Commission of Architectural Review

5. COA-137123-2023	Final Review	Meeting Date: 10/24/2023
Applicant/Petitioner	Catherine Easterling	
Project Description	Rehabilitate an existing auto-garage and surrounding site.	
Project Location		
Address: 2018 East Broad Street		
Historic District: Shockoe Valley		
<p>High-Level Details:</p> <ul style="list-style-type: none"> • The applicant plans to rehabilitate the exterior and interior of the historic building in order to make it a viable repair shop once again. • Plans for this project include repairing historic windows and replacing newer windows. • The applicant will be replacing the boiler room roof and the main building roof to ensure that both buildings are structurally sound. • As part of this project, the applicant will be removing the large billboard from the east side and adding landscaping around the site. • New signage will be added to the front of the building, which will not be internally illuminated. • Overgrowth on the east side of the lot will be cleared. Additional parking and an employee break area will be added to the east side of the site.

Figure 16. Aerial view of the proposed landscaping around the site and planned exterior hardscaping.

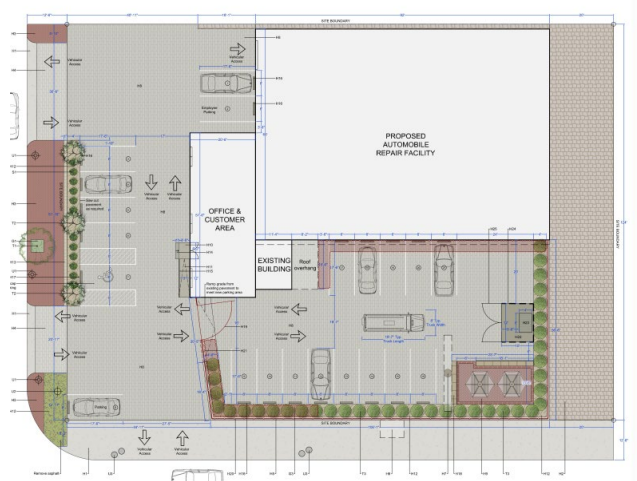
<p>Standard for Site Improvements: Landscaping, page 76.</p>	<p><i>Landscaping is an essential component of any well-designed urban streetscape, and it is a crucial component to the preservation of structures throughout the City.</i></p> <p><i>8) Landscape design should enhance the streetscape and contribute a strong aesthetic along street frontages. Appropriate landscaping should buffer the visual severity of surface parking lots from view.</i></p>	<p>New shrubs, trees and planting sections will be added to the east section of the lot.</p>
